Submissions received on Akaroa Wharf Replacement, March 2022

The main wharf in Akaroa has been in operation for around 130 years, and is currently in fairly poor condition. Christchurch City Council (CCC) has proposed that the wharf should be rebuilt, in broadly similar size and location as the existing wharf, and has invited public comment. The comments of ARRA are given below.

Ambulance attending a call out March 2019

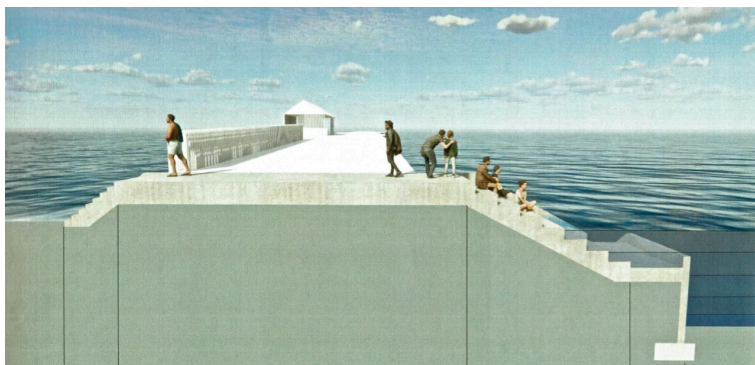
7. As the owner of the Akaroa Wharf, the Council has a responsibility and duty of care with regard to individuals walking on and using the structure. Health, safety and wellbeing should therefore be high priorities. The Council needs to reduce the element of risk for anyone who accesses or uses the wharf.

8. The Council should construct the wharf in a manner which ensures the safety of members of the public as well as commercial users. The Akaroa Wharf is a dual purpose facility, it serves visitors, recreational users as well as a commercial operators.
  - c. Safety measures are a requirement for an active, working wharf and port facility with regard to commercial activity. The future use of the structure should include the needs of fishermen, aquiculture, tourism operators, coastal shipping, passenger transport, cruise tenders, recreational users and members of the public.
  - d. Commercial operators necessitate the use of machinery, vehicles, vessels, equipment, cranes, tools, pipes, delivery and emergency vehicles and forklifts on the wharf (refer to Enviser report page 14, Table 7: record of infrastructure requirements from wharf users).

Option A, Isthmus, September 6, 2021

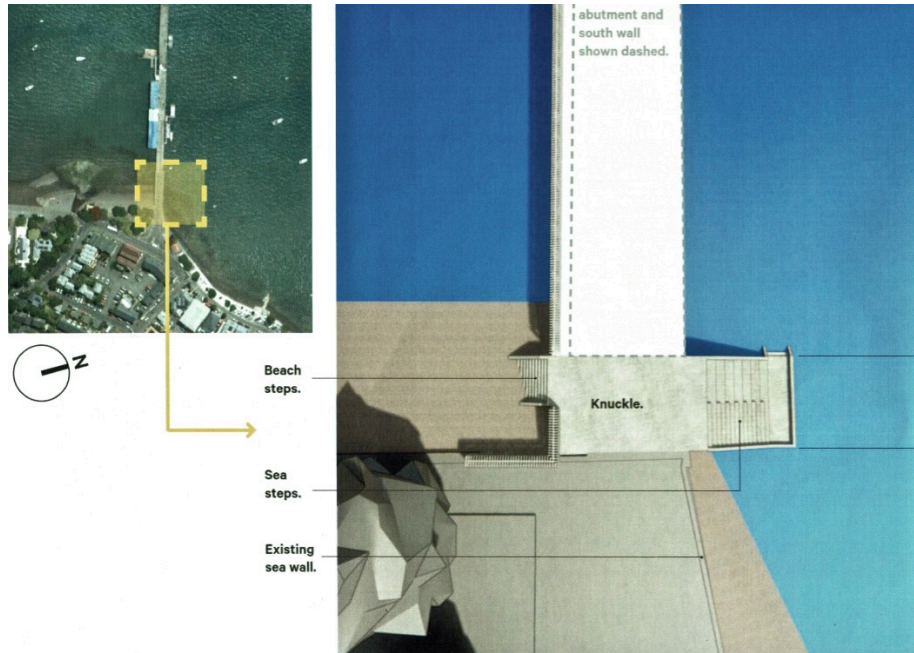
The Knuckle will encourage individuals and children to gather in the vicinity.

In our view, the Knuckle requires an independent assessment with regard to risk and safety issues.

South side of the Akaroa Wharf next to the Britomart Reserve, 2022

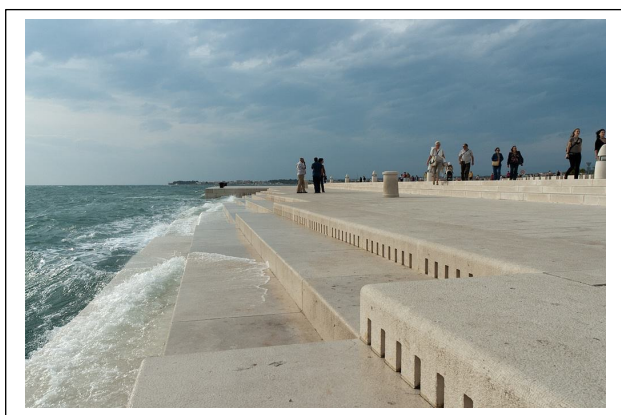
The Knuckle is intended to provide access to the 'beach' and water as an expression of culture associations, however public access to the water is already available in close proximity to the wharf as seen in the image below. (photo: Victoria Andrews)

Location of the Knuckle at the south side of the wharf.

No consideration appears to have been given to sea level rise with regard to the low seawall, Britomart Reserve and access to the shoreline.

- Cultural associations relating to accessing the water can be accommodated via the low seawall area at the Britomart Reserve which does not require steps, modifications or visual intrusions.
- If steps are deemed to be a cultural requirement then decking with steps down to the water's edge can be provided near Fisherman's Rest on the north side of the wharf to avoid congestion and potential conflict between the public and vehicles and equipment used by commercial operators.
